Technical Bulletin

Product Category: RearSight® by Rostra

Part Numbers: 250-8082

Figure 1

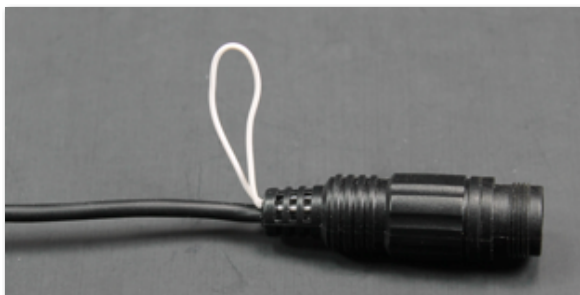
This camera includes parking gridlines overlaid on the video feed by default to assist when parking in reverse. If the driver does not wish for gridlines to be included, simply locate the loop wire connected to the camera harness (**Figure 1**) and cut it in half (**Figure 2**).
